From: Francis, Richard
Sent: 29 October 2014 12:22
To: barry.richards@TLTsolicitors.com
Cc: Bahadoor, Roy
Subject: SN15

RE: CLUB KARMA, STATION HILL, CHIPPENHAM

SOUNDWEB SCHEMATIC FOR CLUB KARMA

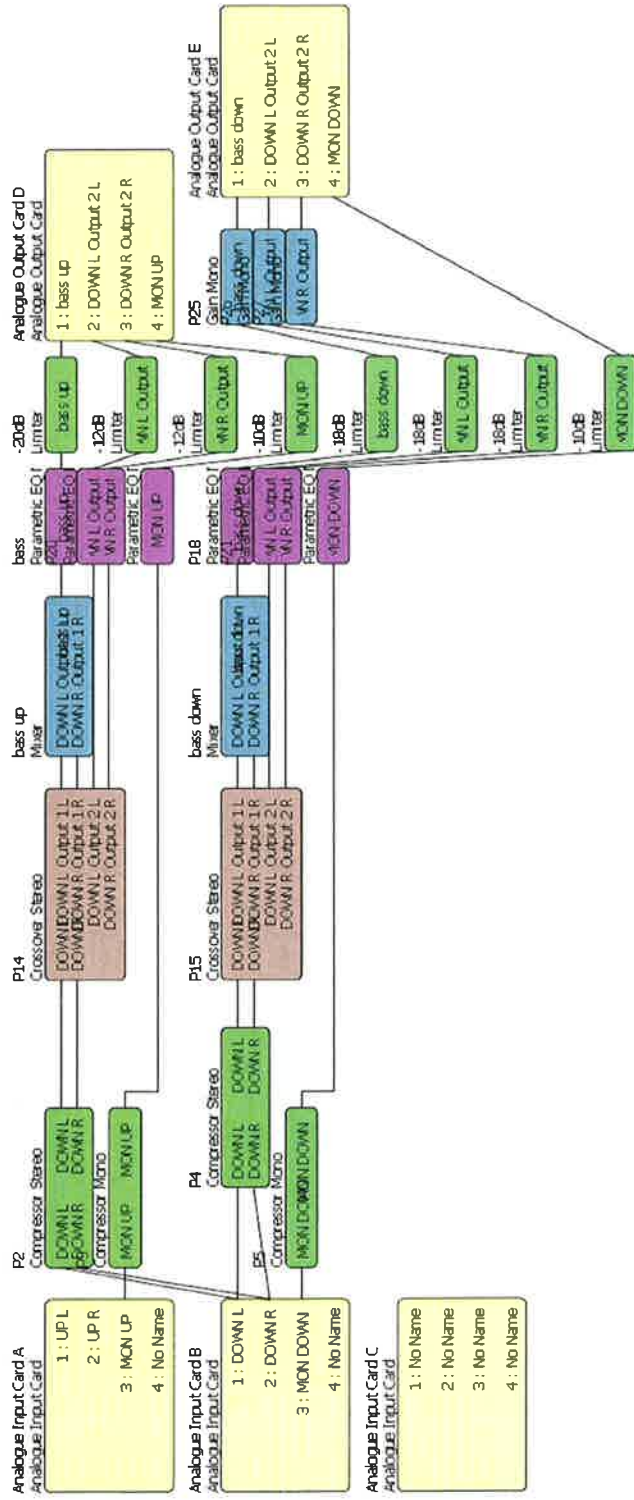
I previously sent you a schematic for the Club Karma files, and I copy it here for reference. Sadly, the software is not terribly user friendly and you might need to be an A-V expert to understand the drawing completely. Essentially, it maps out the inputs, amplifiers, processors and then the outputs from the PA. The area of particular interest to us is the third-last column, in Green. This lists the various outputs from the amplifiers to each part of the club (different signals being sent upstairs and downstairs, to bass speakers and to mid-range speakers - thus allowing separate controls on each).

The annotation above each 'box' indicates the attenuation currently applied to each signal by the SoundWeb system. **Were any alterations made to the PA volume, the numbers here would change.**
